COUNCIL REPORT

File No: FEX 22-01

Subject: **FEX 22-01, Floodplain Exemption, 3320 Turnbull Road**

Figure 1: Horizontal Setback from Unnamed

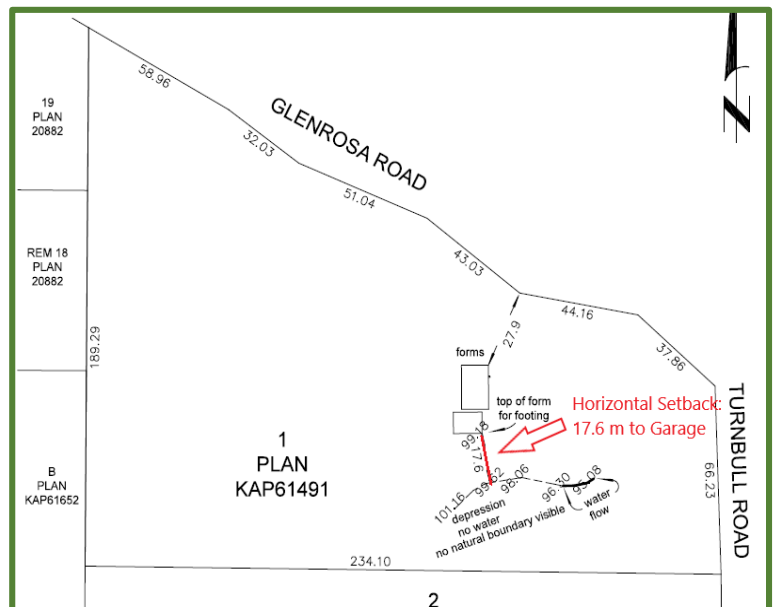
The subject property has a Land Use Designation (LUD) of Rural Residential. The subject property does have an Aquatic Development Permit Area on the property. Based on the 17.6m setback from the dwelling and the stream, the dwelling construction does not trigger the need for an Aquatic DP.

The dwelling complies with the 15 m (49.2ft) minimum siting distance from a stream that is included in the Floodplain Regulations. The proposal does not meet the 1.5 m (4.9 ft) vertical setback above the natural boundary of any stream.
